Crandon Mining Company responses to selected Wisconsin Department of Natural Resources July 31, 1995 comments on the Crandon Mining Company Environmental Impact Report. 1995

Re: Crandon Project - CMC Response to WDNR's July 31, 1995 EIR Review Letter

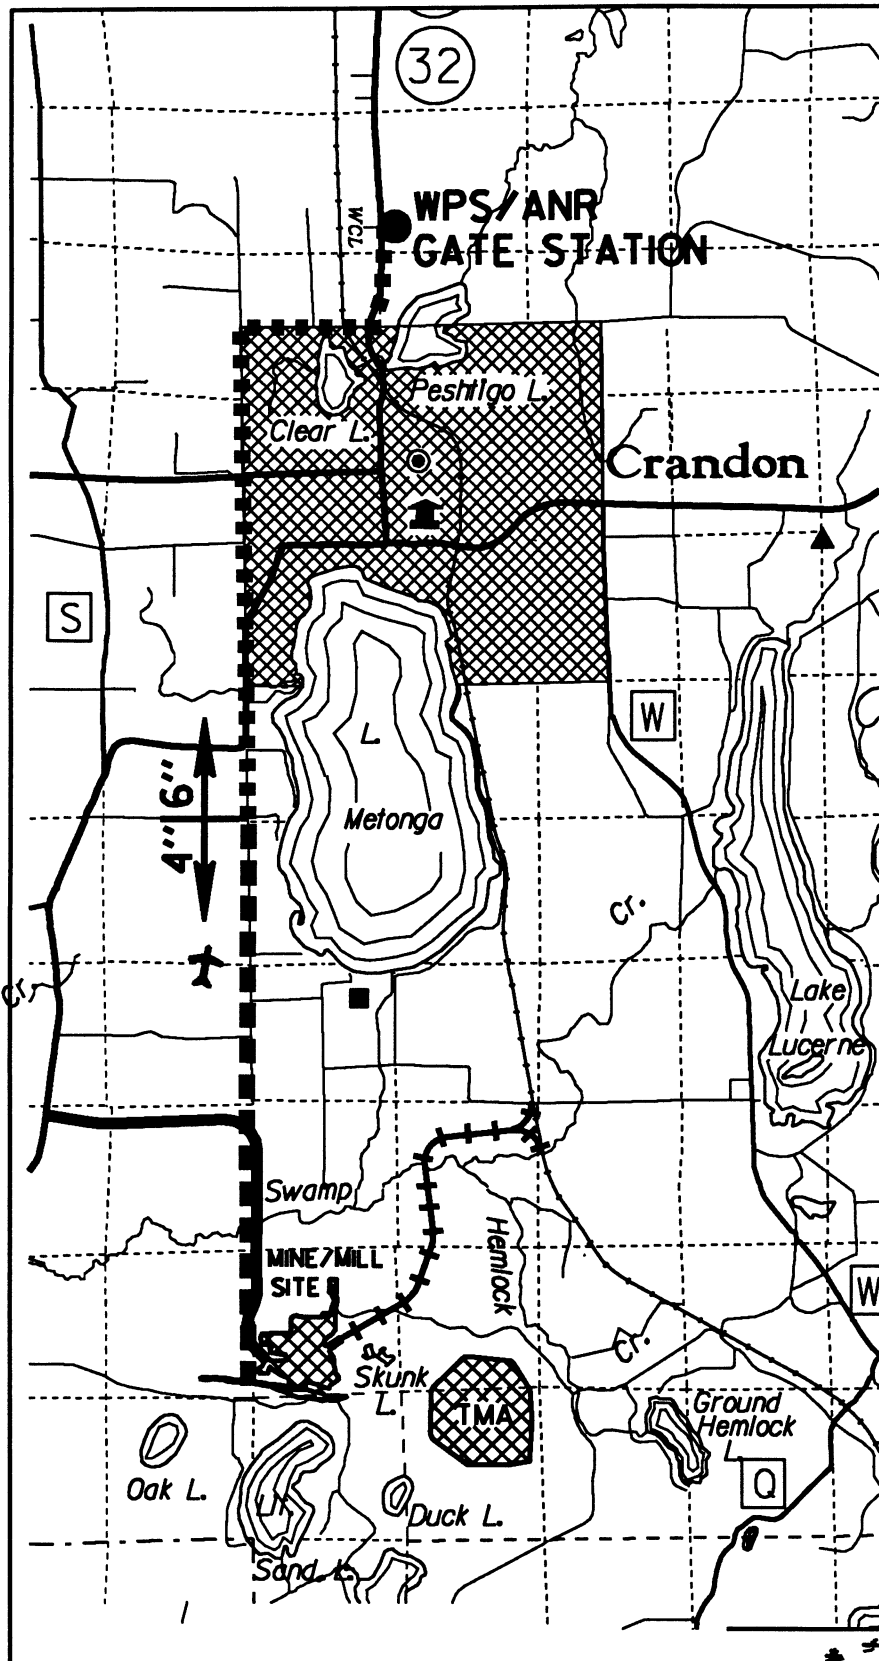
Comment 2: p. 11 Utilities - More detailed route locations should be developed for the proposed gas pipeline route as soon as practicable. Also, would a full six-inch gas pipeline be needed if gas volume is reduced at the connection with the existing six-inch ANR gas pipeline?

Response 2: *Attached to this enclosure is a figure which shows the location of the proposed gas pipeline route. The pipeline would be installed, maintained, and operated by Wisconsin Public Service Corporation (WPSC). The line will consist of a 6-inch diameter steel pipe that would be reduced to a 4-inch diameter steel pipe as it approaches the CMC plant site. The operating pressure of the line would be 150 psi.*

WPSC plans to service other potential customers from the line along its route. Currently WPSC does not have an estimate of the number of additional customers it will service from the line. If a gas pipeline were to be installed strictly for the Crandon Project, its diameter would be four inches, with an operating pressure of 150 psi.
